ADDENDUM NO. ONE (1)

**STAIR REPLACEMENT FOR LONG TERM PARKING LOT
at the
CHARLOTTESVILLE-ALBEMARLE AIRPORT
CHARLOTTESVILLE, VIRGINIA**

**TBI Project No. 2215-1502
IFB No. 2016-100**

August 22, 2016

3 DETAIL: TREAD & RISER
A1 | A1
3'-1'-0"

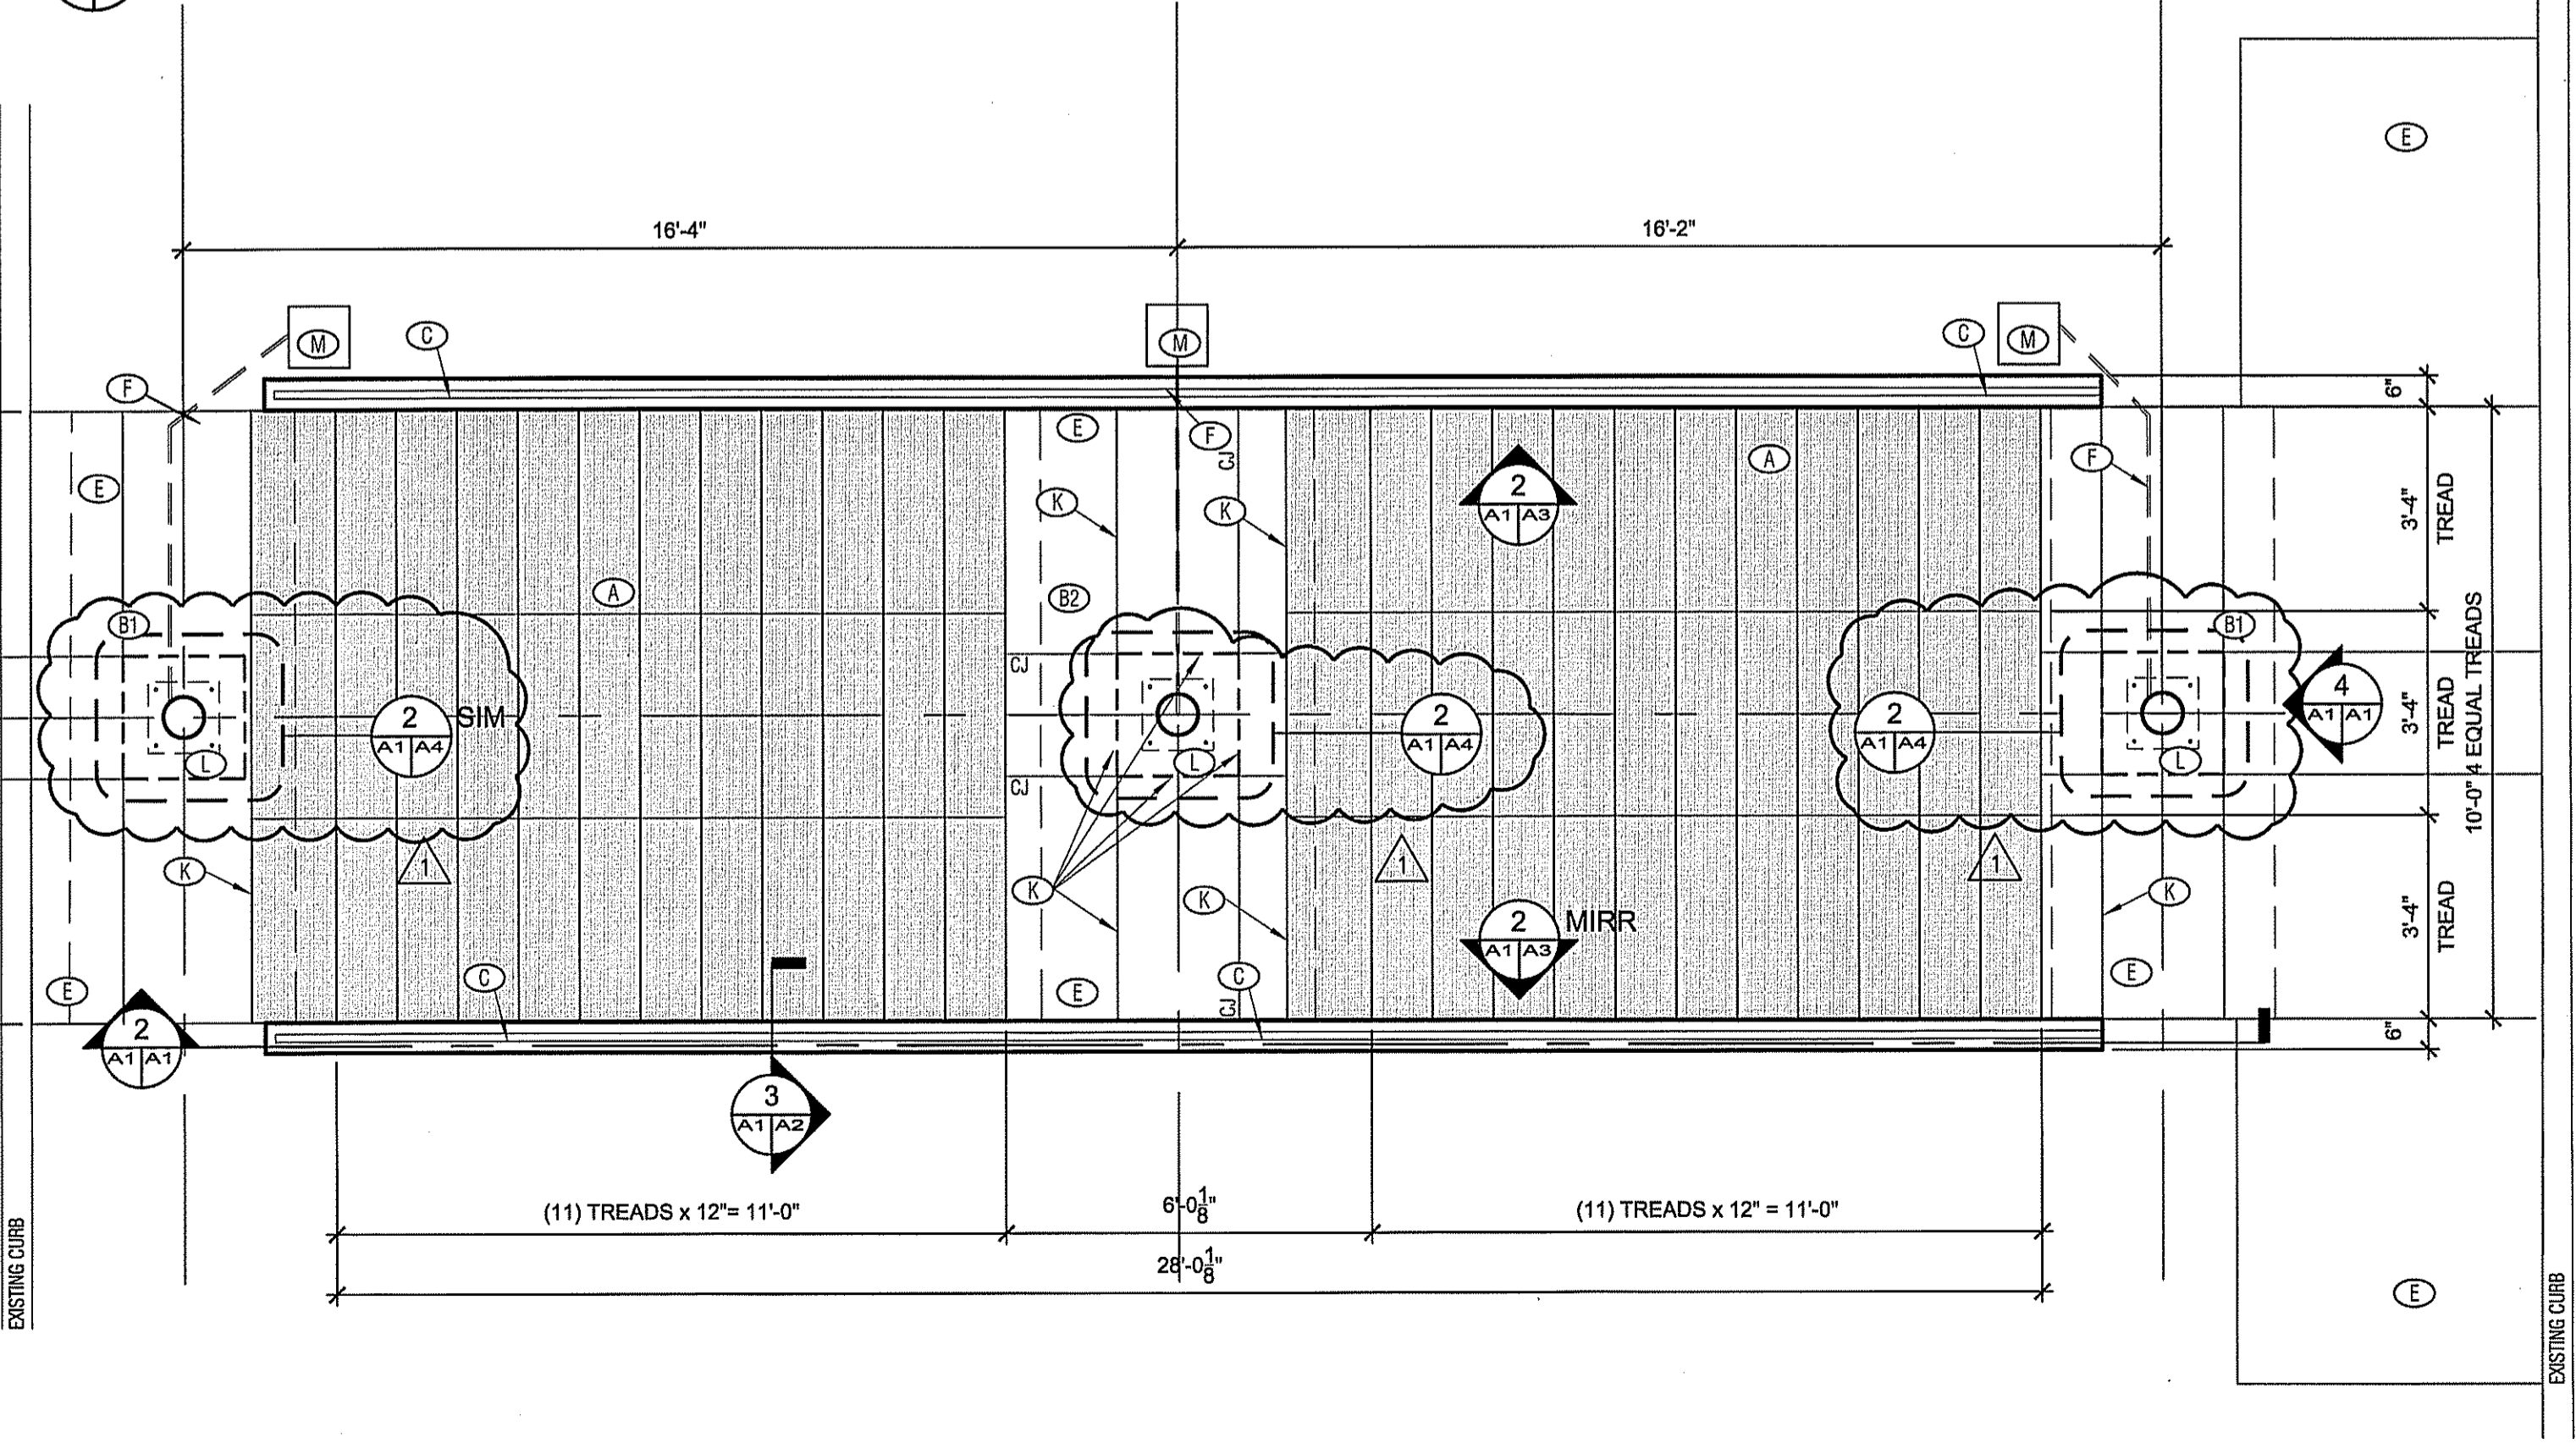
Bid Alternate 2 includes providing fifteen (15) spare pre-cast treads and accessories with the thin brick installed per Detail 3, Sheet A1. The spare treads shall be delivered to the Owner on a pallet and stored at the Owner’s preferred on-airport location. The contractor shall coordinate delivery with the Owner prior to shipping the spare treads.
